»» **Service Bulletin**

Number: B01-01 A

Subject: Push Rod Shroud Tube Interference with Cylinder Head Cooling Fins

Engine Application: Lycoming 360 and 320 Series Engines with Superior Cylinder Stud Assembly Part Numbers SL36000W-A1, SL36000N-A1, SL32000W-A1, SL32000N-A1 and SL32000NA-A1 Manufactured in October and November of 2000.

Figure 1. Exhaust Side

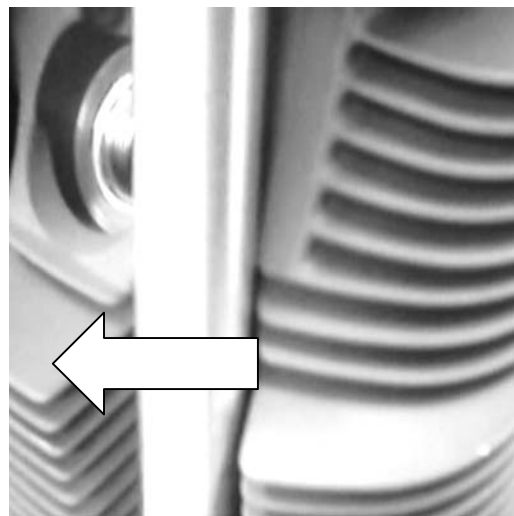
In the event that cylinder assemblies have already been installed, the clearance between the push rod shroud tubes and the cylinder head must be inspected to verify a minimum of .010 inches of clearance at all points. This is most easily accomplished using a .010 inch thick feeler gage, bent to fit around the back side of the push rod shroud tube. Several thinner feeler gages together equaling .010 inch thick may also be used. The .010 inch gage must pass freely up and down the Shroud tube between it and the cylinder head at all points. Any interference will occur at fin numbers 9 through 13, (counted from the bottom or barrel end of the head) toward the outside of the head on both tubes. The figures on page 3 of this Service Bulletin show the areas where interference may occur.

If interference is detected, the push rod and shroud tube must be removed and the area of interference must be ground down until proper clearance is achieved. This can be accomplished with a rotary file or sanding drum, since very little material must be removed. Use extreme care to cover all exposed parts, such as the valve lifters and the rocker box area to prevent contamination from the chips and abrasive. Do not remove more than .060 inch of material from the interfering surfaces.
